PERMIT INFORMATION

Permit Number: C-1981-028 Mine Name: Keenesburg Strip Mine Operator: Coors Energy Company Operator Address: Mr. Ben Moline PO Box 4030 Golden, CO 80402

INSPECTION INFORMATION

This inspection, conducted by Rob Zuber of DRMS, was prompted by a Coors Energy Company (CEC) application for a Phase I bond release (SL-11). Ben Moline represented CEC during the inspection. Other participants included Dan MacKinnon and D.J. Cunningham of the Office of Surface Mining (U.S. Department of the Interior).

Please see Figure 1 from the application (below).

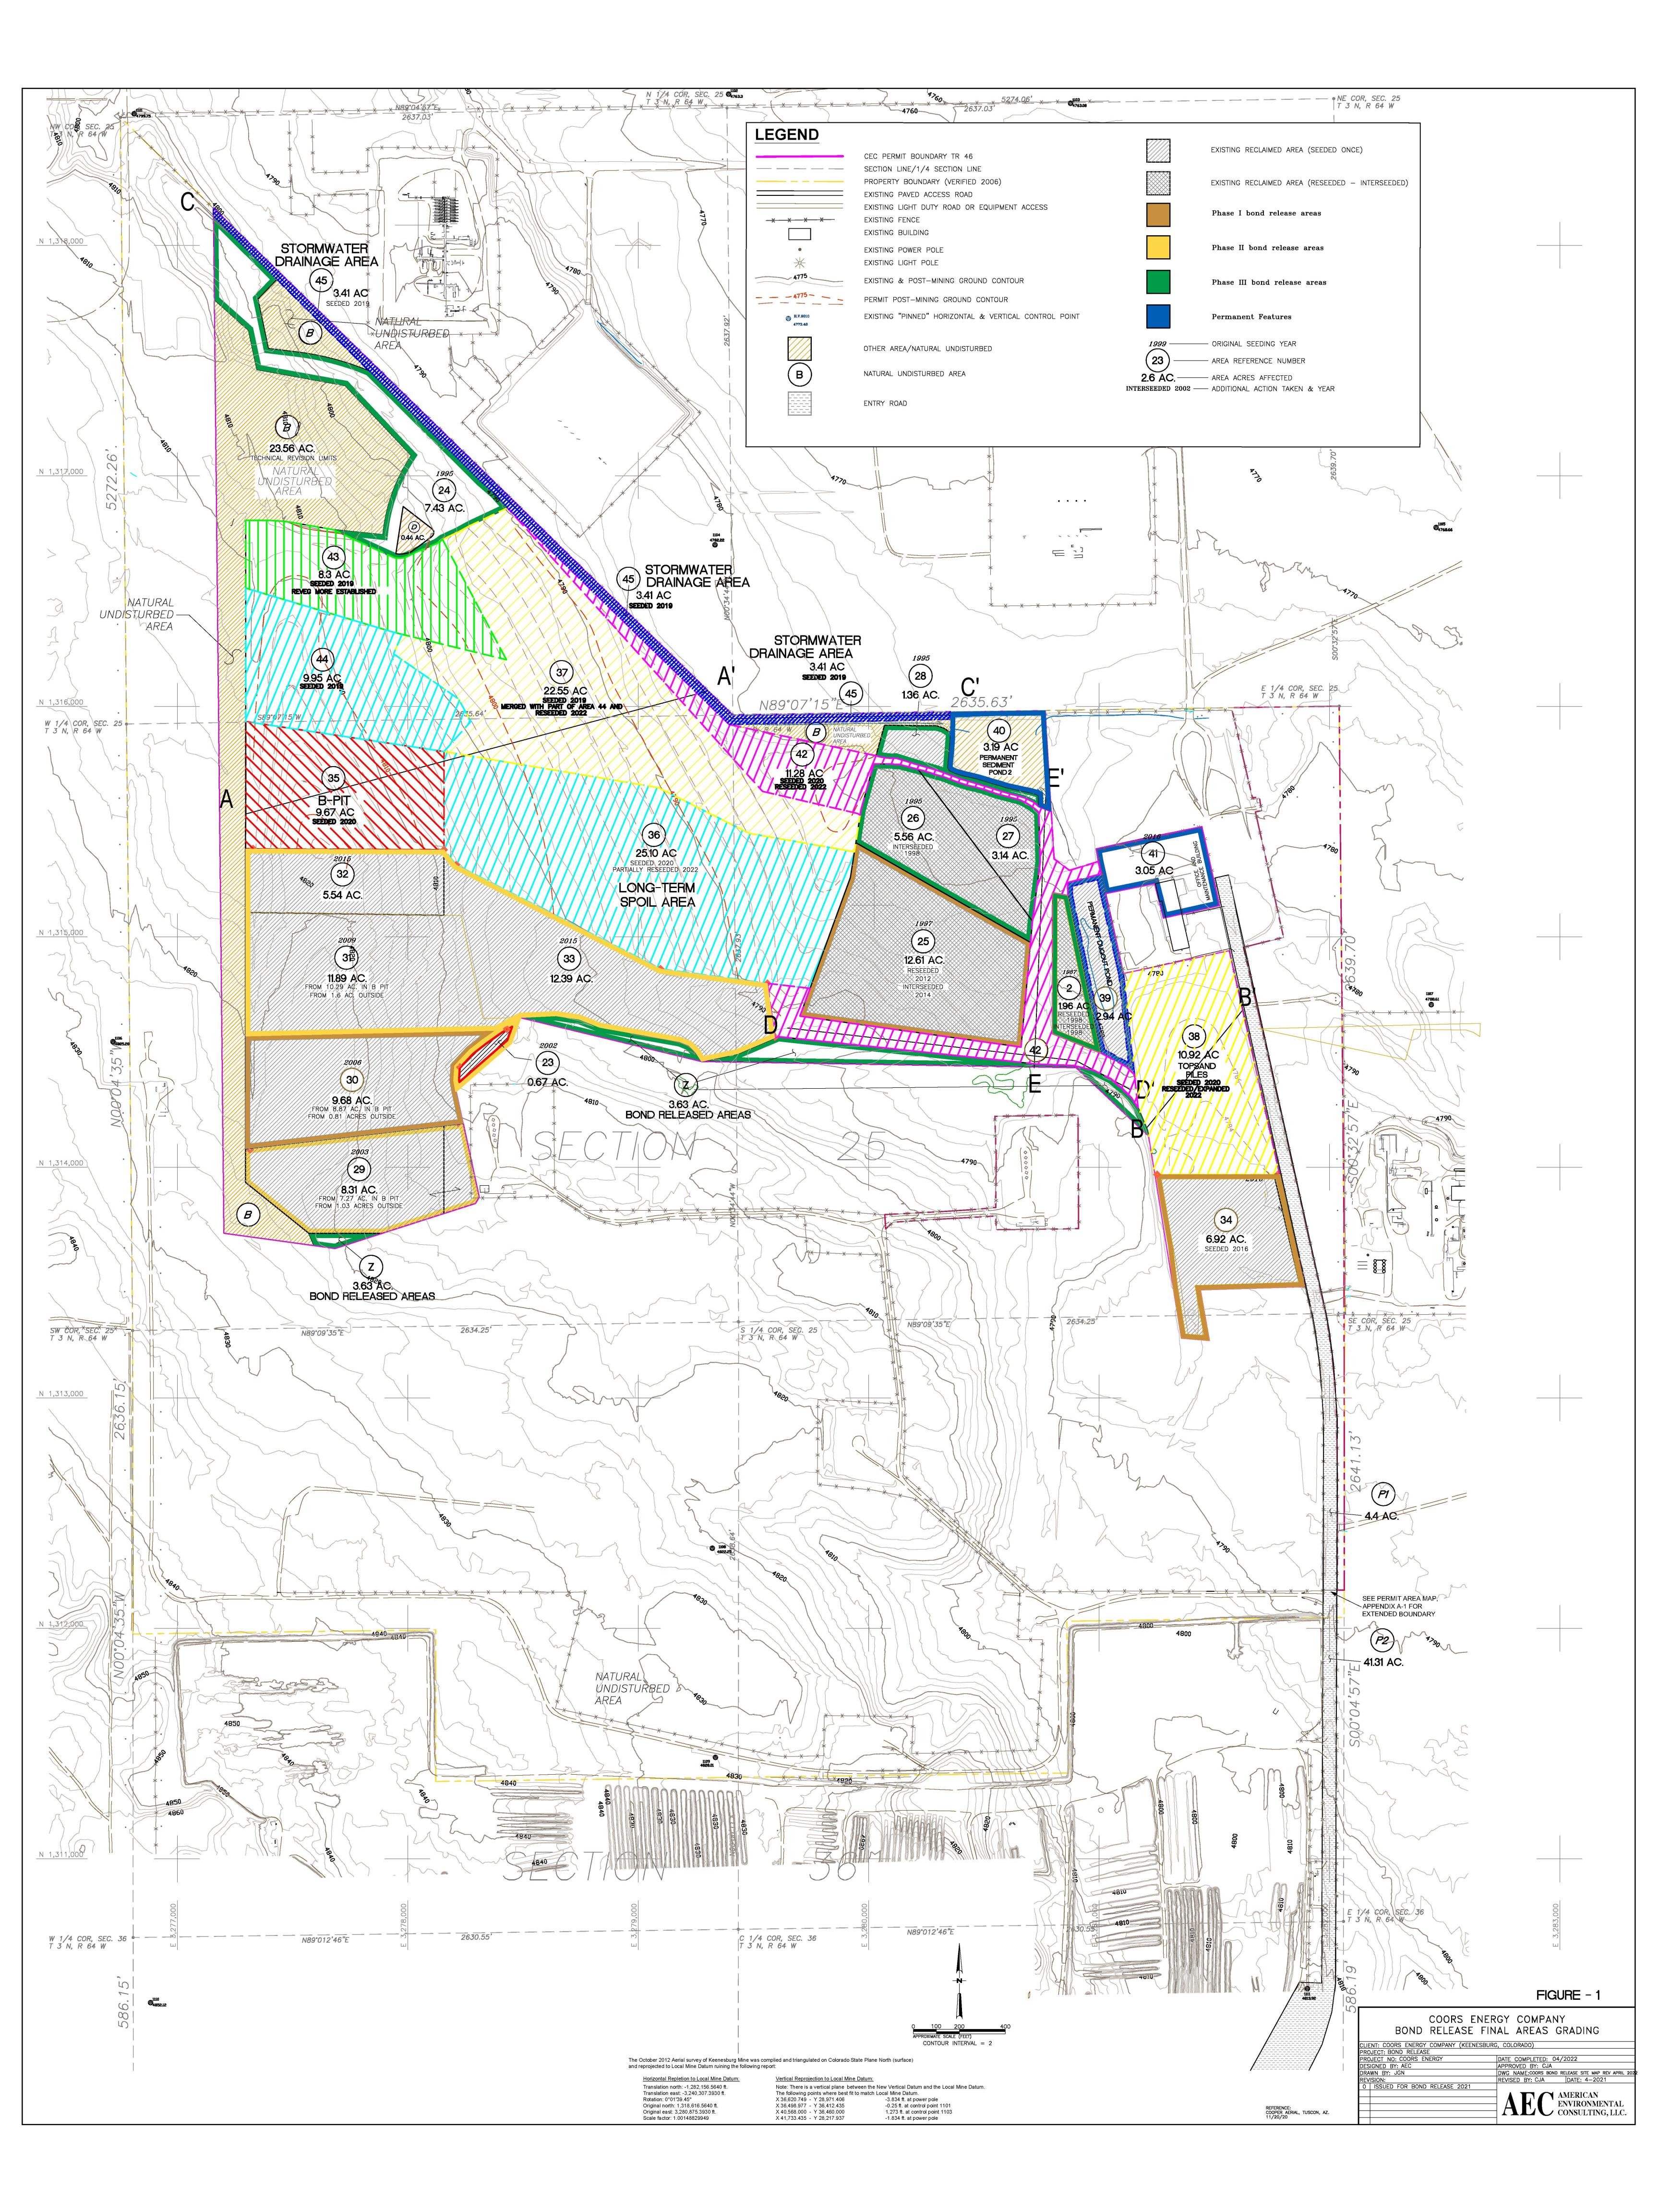
The application requests Phase I release for eight areas:

- Areas 35, 43, and 44 are basically the reclaimed B Pit.
- Areas 36 and 37 generally include the reclaimed Long Term Spoil Area and Topsand Pile A-3.
- Area 38 is the location where Topsand Piles A-1 and B-1 existed prior to reclamation.
- Area 42 consists of reclaimed roads as well as a storage area west of Sediment Pond 2.
- Area 45 includes the perimeter ditch that extends from near the northwest corner of the site to Sediment Pond 2.

The drainage patterns for seven of the eight areas match the reclamation plan for the site, including Appendix Q-1 in the Permit Application Package. The observed drainage patterns are as follows:

- Within Areas 35, 43, and 44, the general drainage pattern is to the northeast. On the west side of these areas, however, there is a swale that drains to the north and then east across the north portion of Area 43.
- Areas 36 and 37 drain to the northeast.
- Most of Area 42 is essentially flat. The "steepest" portion, the reclaimed road west of the Dugout Pond, drains to the north at approximately a 1% slope.
- The ditch in Area 45 drains to the southeast and then east to Sediment Pond 2.

Area 38, the possible exception to the paragraph above, requires further discussion between DRMS and CEC. This will be part of the adequacy review for SL-11.

No problems were identified with erosion at any of the eight areas. The channel in Area 45 appears to be functioning well, as there is no sign of water flowing over the banks, and years of inspecting this channel have not indicated problems.

The results of using the rangefinder show that slopes at the site (estimated by DRMS) are generally in agreement with slopes in the application:

- The Area 35 slope to the northeast (approximately transect A-A' in the application) of approximately 5% is somewhat above the slope indicated on the cross-section in the application, approximately 3%.
- Area 38 slopes to the southwest (approximately transect B-B' in the application) at 1.8%. A comparison cannot be made to the application data at this time. Details on the topography of Area 38 need to be developed during the adequacy portion of the review of this application.
- The portion of Area 42 that is due west of the Dugout Pond slopes to the north at 1.3%. This is close to the slope of 1.1% estimated from the map in the application.
- Area 44 slopes to the northeast at approximately 3.3%. This is close to the slope of 2.6% estimated from the map in the application.

The GPS data also suggest that the slopes of cross-sections in the application are in agreement with DRMS

- estimates. However, the DRMS elevation data collected with GPS is somewhat suspect for two reasons:
 - During collection of data in the field by DRMS, at some of the points, the software indicated that the accuracy was as poor as 0.7 meter.
 - The elevations collected by DRMS do not match the elevations in the application, and the differences vary from approximately 0.2 feet to six feet.

Staff at the Office of Surface Mining are further analyzing the data for the source of errors (and possible correction), and this analysis may inform the forthcoming adequacy review by DRMS.
